Model: OR-C1	Date: 12-Sep-11	No.: RD120001c
--------------	-----------------	----------------

Subject: Firmware Release Note: Fax		Prepared by: J. Kitagawa	
From: 1st Tech Service Sect.MFP/Printer Tech Service Dept.,			
Classification:	<input type="checkbox"/> Troubleshooting <input type="checkbox"/> Mechanical <input type="checkbox"/> Paper path <input type="checkbox"/> Product Safety	<input type="checkbox"/> Part information <input type="checkbox"/> Electrical <input type="checkbox"/> Transmit/receive <input checked="" type="checkbox"/> Other (Firmware)	<input type="checkbox"/> Action required <input type="checkbox"/> Service manual revision <input type="checkbox"/> Retrofit information <input checked="" type="checkbox"/> Tier 2

This RTB has been issued to announce the firmware release information for the **Fax**.

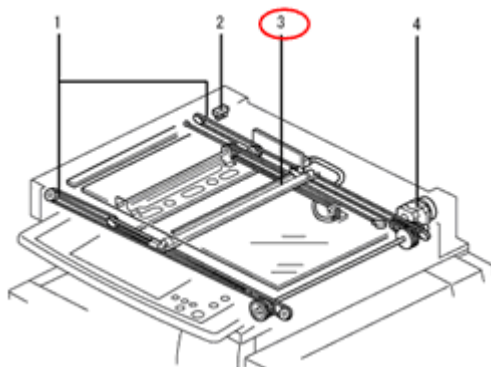
The scanner carriage, circled in red below, touches the front frame when the user pushes down on the original.

- 1) Advise users not to push down on the original when making copies using the exposure glass.
- 2) If the SC still occurs, remove the **center** rubber cushion from the exposure glass (see details below).

6.Scanner Section2 (D120/D121/D122/D139/D140/D141)

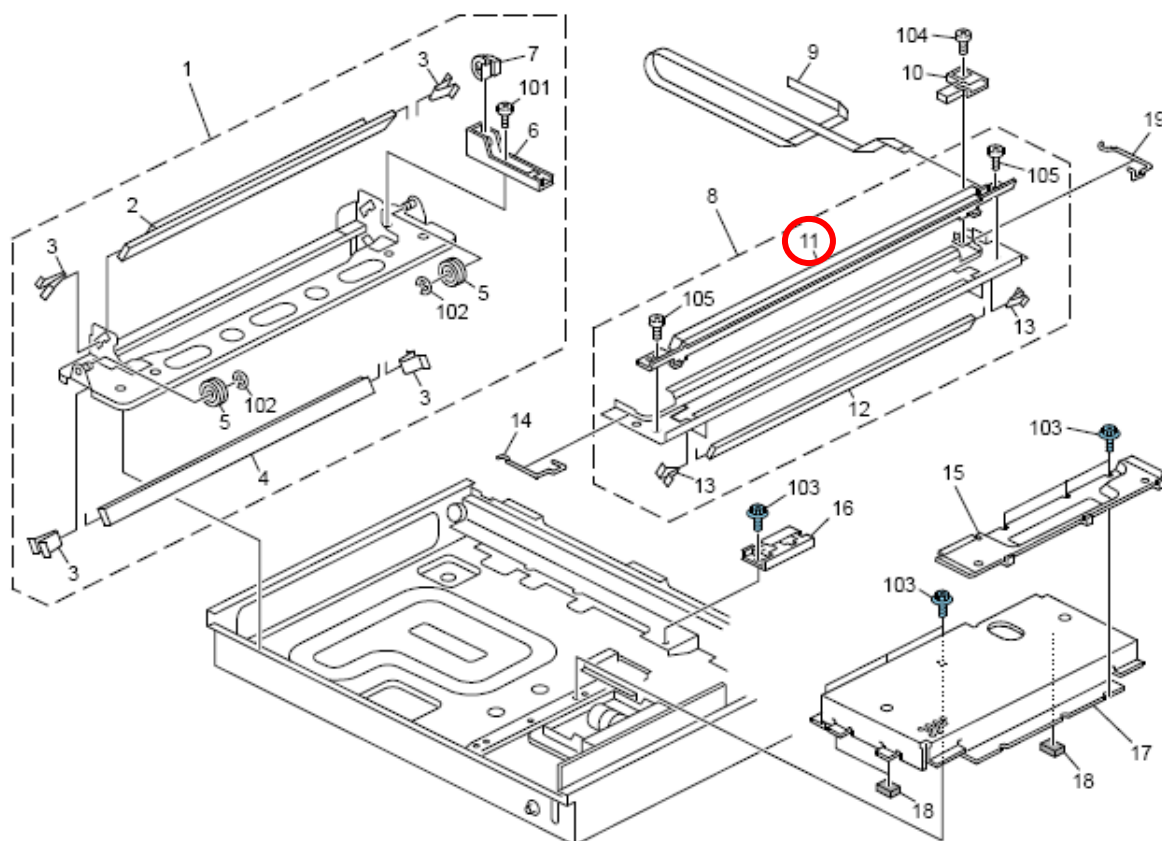
3) If the SC still occurs, replace the LED assembly with the following new part:

Old part number	New part number	Description	Q'ty	Int	Page	Index	Note
D1201732	D1201734	ILLUMINATION UNIT:LED:ASS'Y	1-1	X/O	19	11

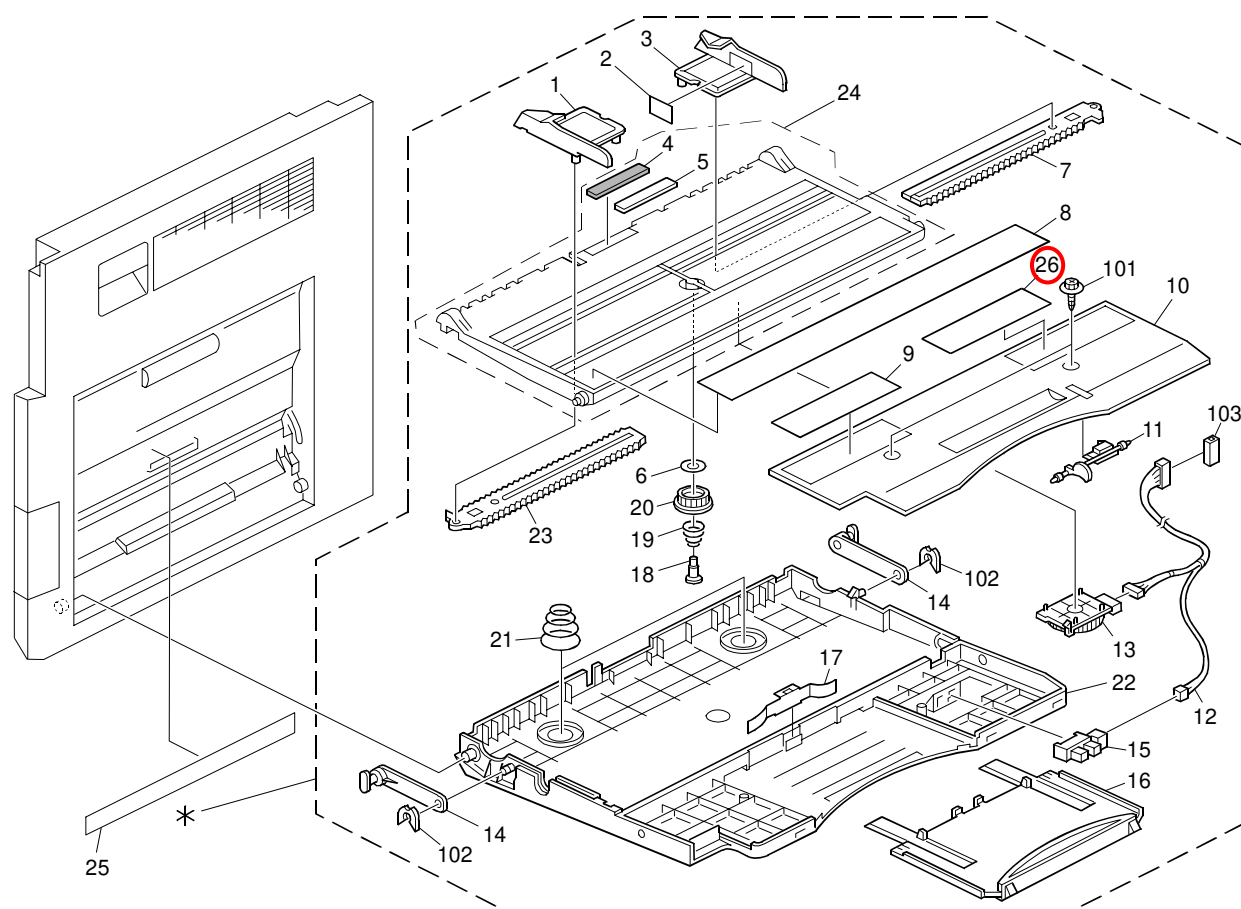
Change: A decal was added that urges the operator to extend the tray extension when feeding A3 sheets from the bypass tray.

Reason: To ensure that bypass jams do not occur when A3 sheets are fed from the bypass tray. (This can happen if the operator does not extend the extension tray, since the machine cannot detect the paper size correctly).

9.Paper Feed Section 1 (D120/D121/D122/D139/D140/D141)

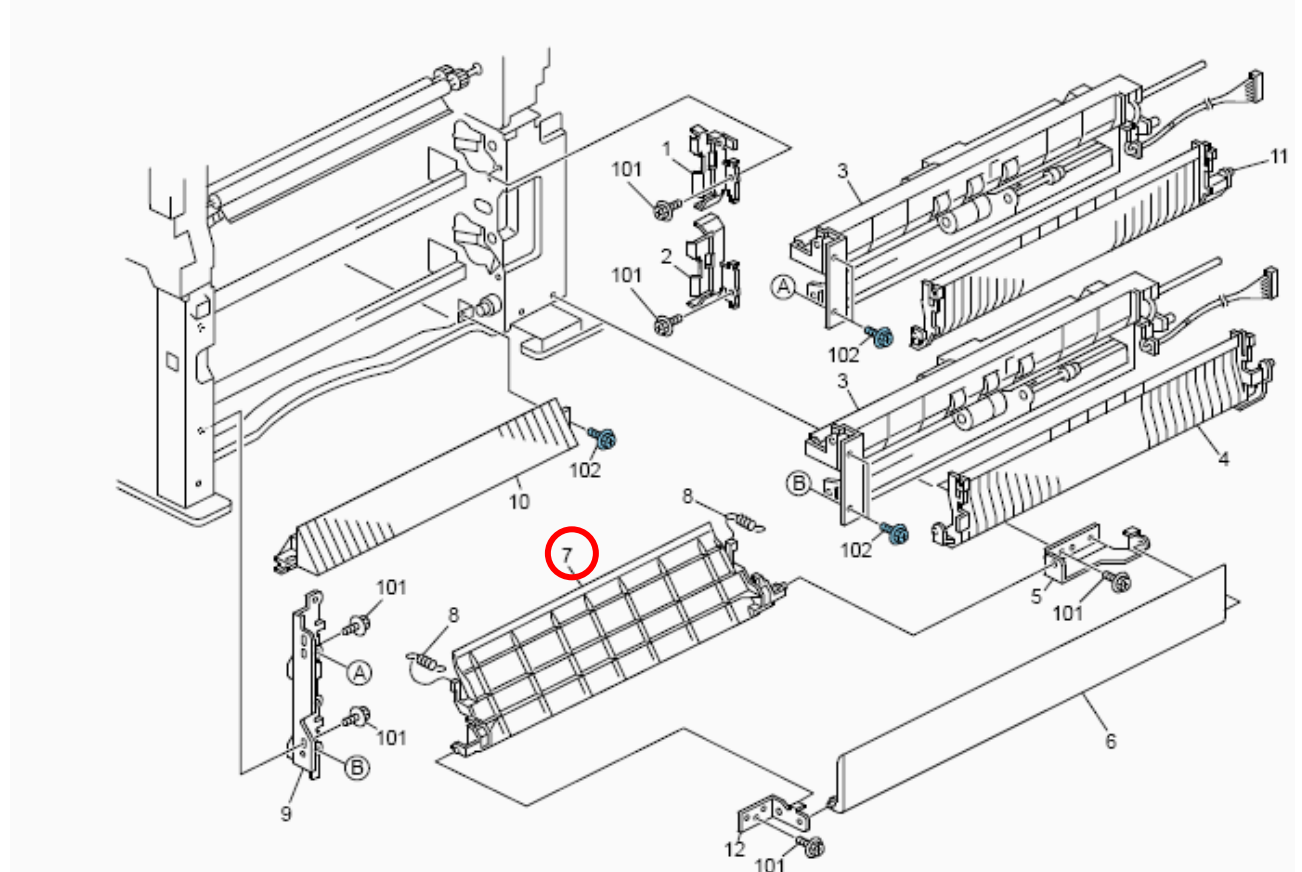
Part number	Description	Q'ty	Page	Index
D1202962	GUIDE PLATE:VERTICAL TRANSPORT:RIGHT	1	25	7

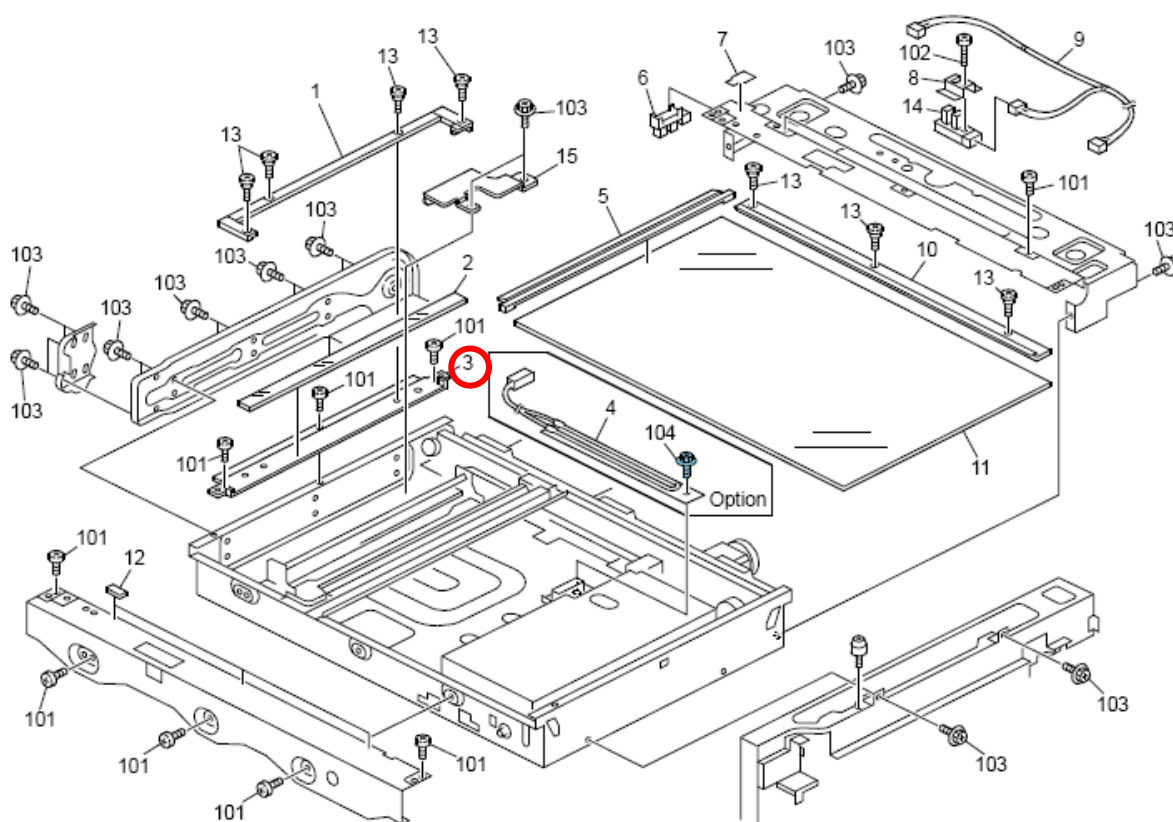
Replace the document feeder bracket with the following service part:

Part number	Description	Q'ty	Page	Index	Note
B2381803	DOCUMENT FEEDER BRACKET	1	17	3

Note: This symptom does not occur with the service parts DF bracket shown above. It only occurs with the bracket installed in the machine at the factory.

D580 (PB3130 Paper Feed Unit) Point To Point Diagram (10/29)

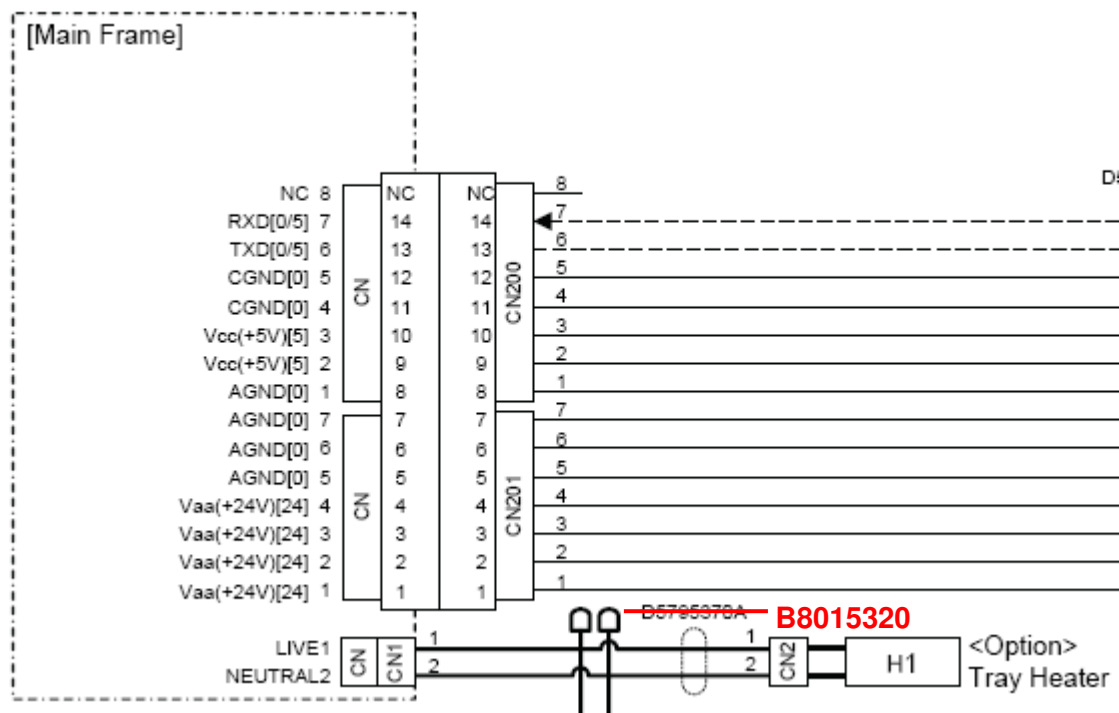
Incorrect P/N	Correct P/N	Name	Page
D5375370	B8015320	HARNESS - HEATER	10/29

D581 (PB3140 Paper Feed Unit) Point To Point Diagram (12/29)

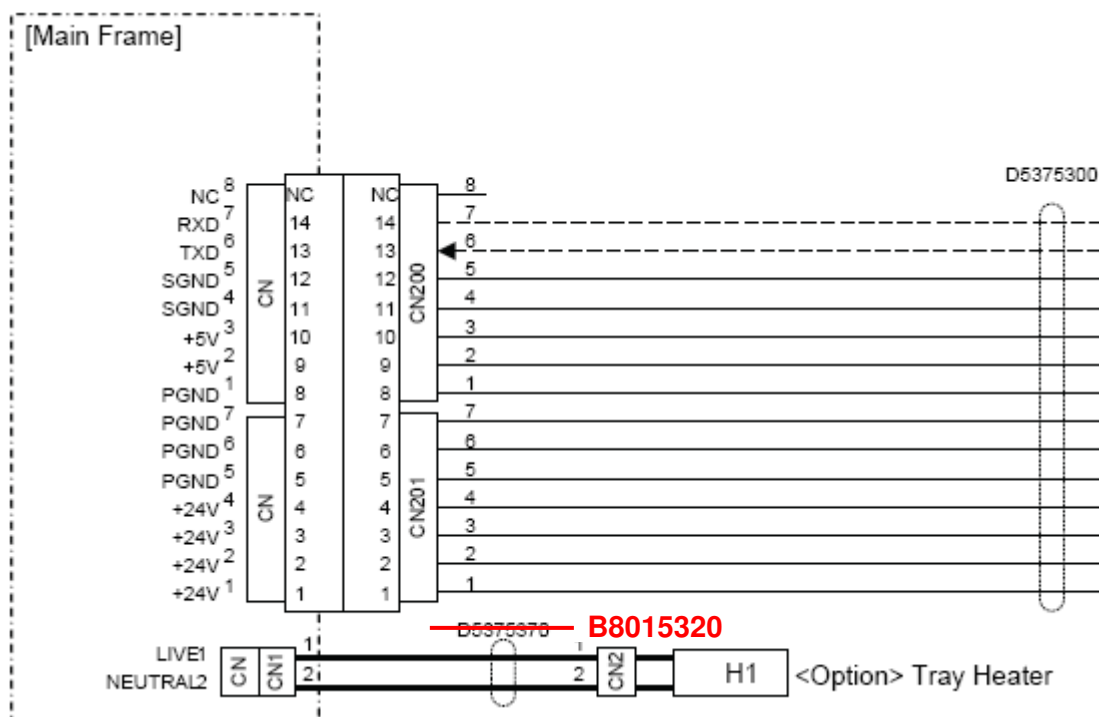
Incorrect P/N	Correct P/N	Name	Page
D5375370	B8015320	HARNESS - HEATER	12/29

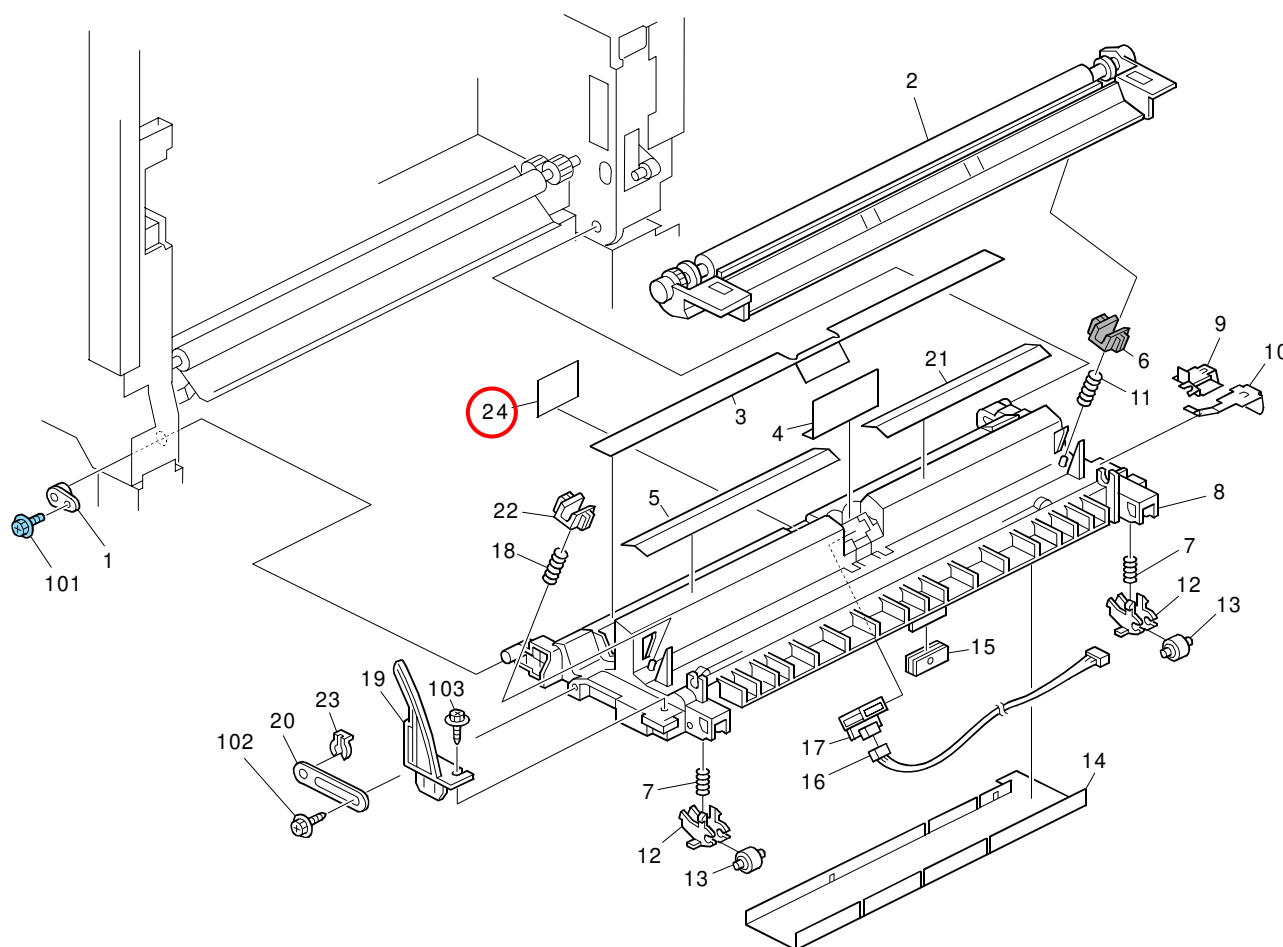
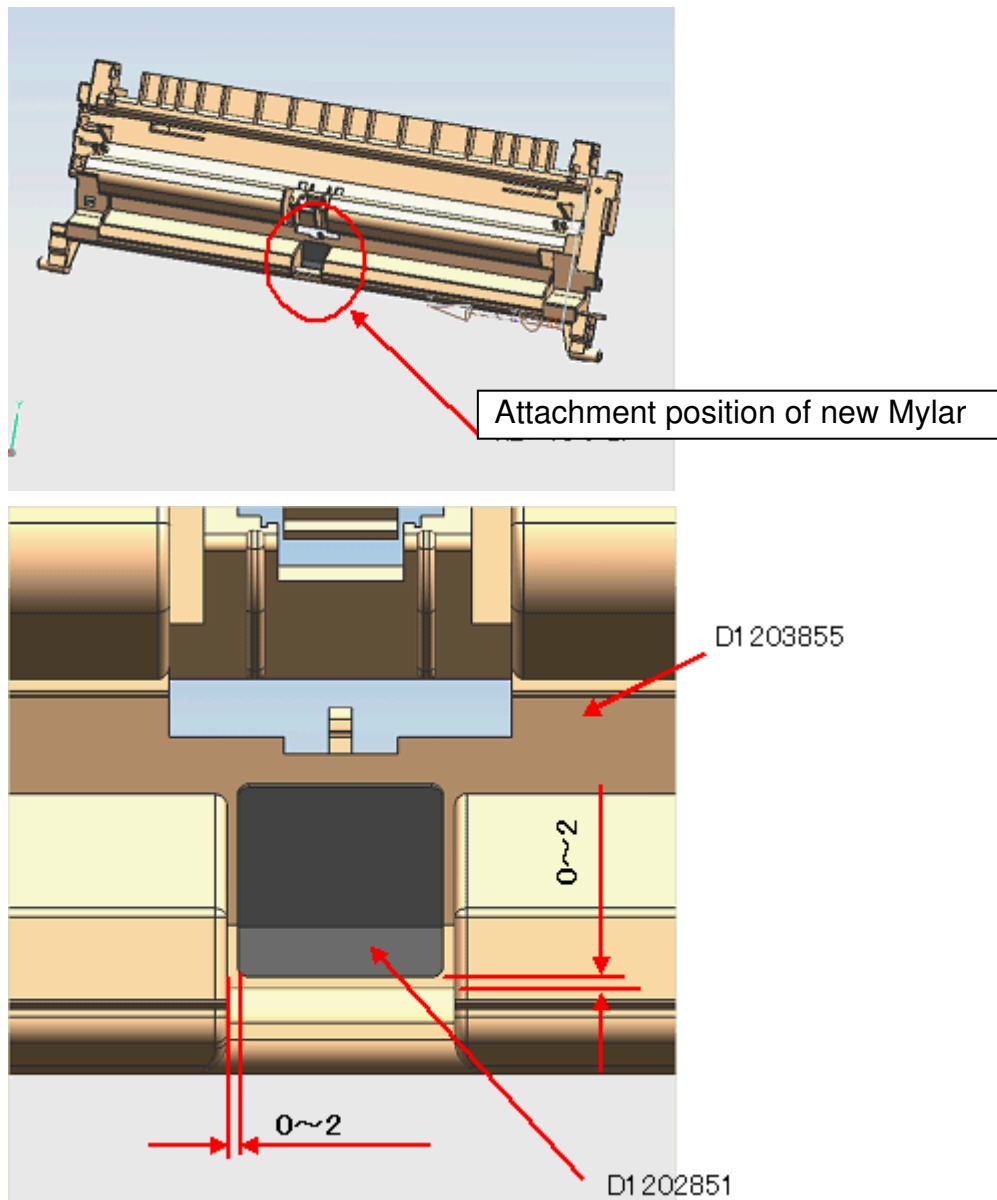
Change: A Mylar was added to the cover of the transfer unit.

See page 2 for diagrams showing the attachment position.

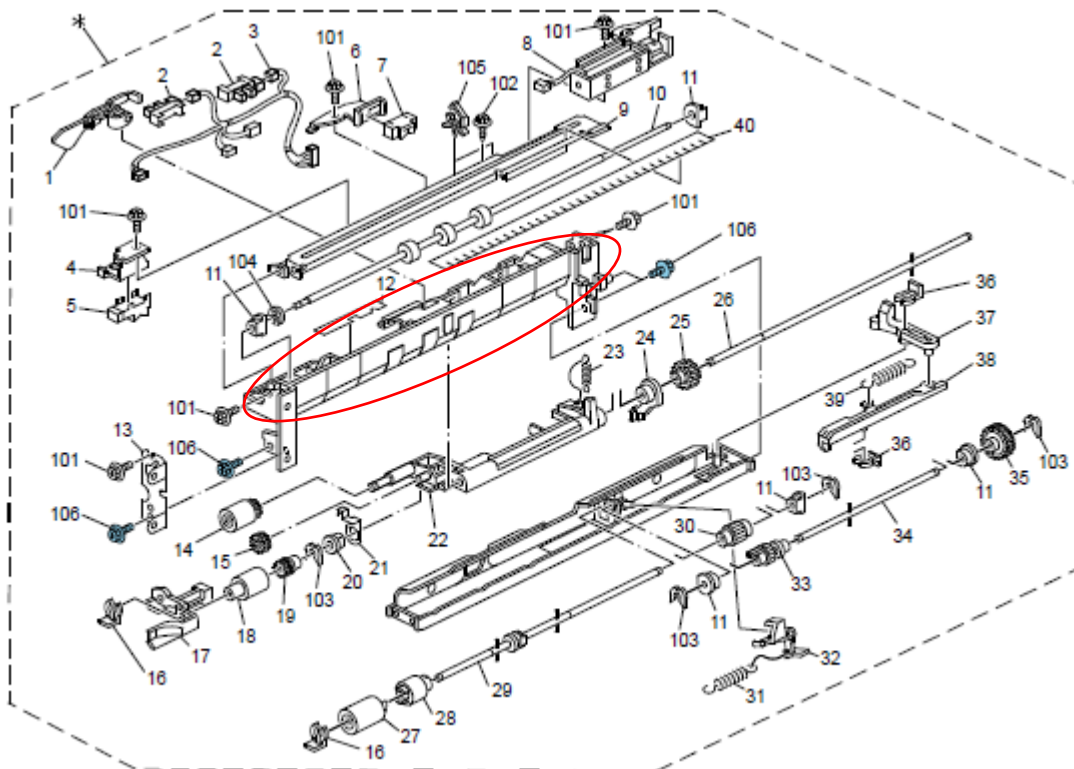
The part circled in red below shrinks in low temperatures, which can sometimes cause the transport roller (index #10) to lock up.

Old (P/N AA082152):

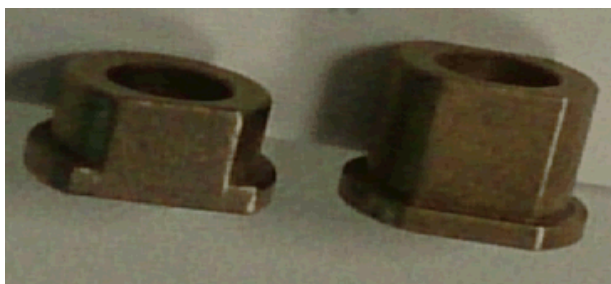
Replace the bushing (index #11) with the modified one.

NEW (P/N AA082117):

16.Transfer Unit (D120/D121/D122/D139/D140/D141)

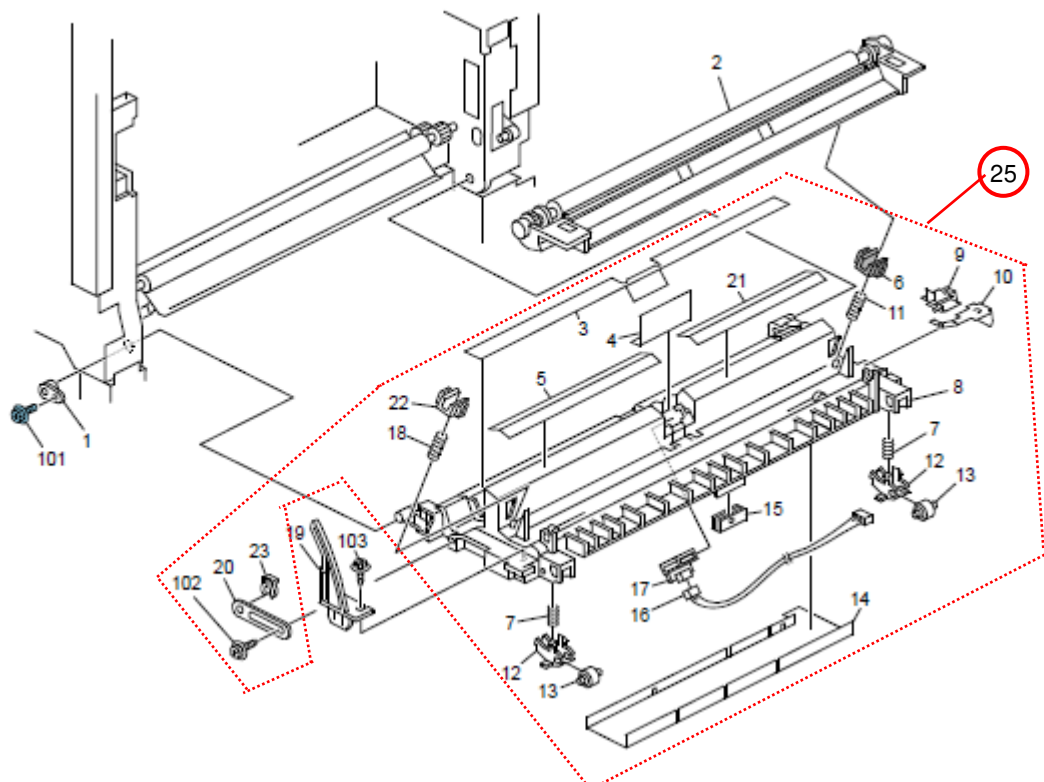
Change: The parts boxed in red in the illustration were registered as an assembly.

Reason: To meet requests from the field.
